Appln No. 10/758,762
Amdt date April 28, 2006
Reply to Office action of January 30, 2006

REMARKS/ARGUMENTS

FIG. 12

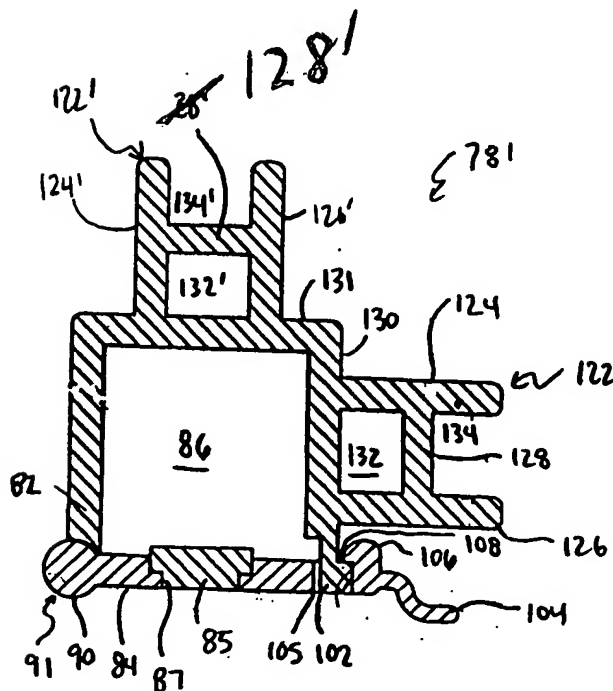
The Examiner has objected to the drawings under 37 CFR §1.84(l) and §1.84(u)(2) because the view numbers are not larger than the reference characters and because the lines on the drawings are not sufficiently dense, dark, uniformly thick and well-defined. The Examiner has further objected to the drawings specifically because reference character 28' in Figure 12 should be labeled 128' for consistency and because reference characters for the mounting brackets at the ends of the posts in Figure 16 should be labeled 78 rather than 78". Applicant has amended the drawings and requests that the objections to the drawings be withdrawn.

The attached 2 sheets of annotated drawings include changes to FIGs. 12 and 16. The attached 12 sheets of replacement drawings, which include FIGs. 1-16, replace the original drawings as filed.
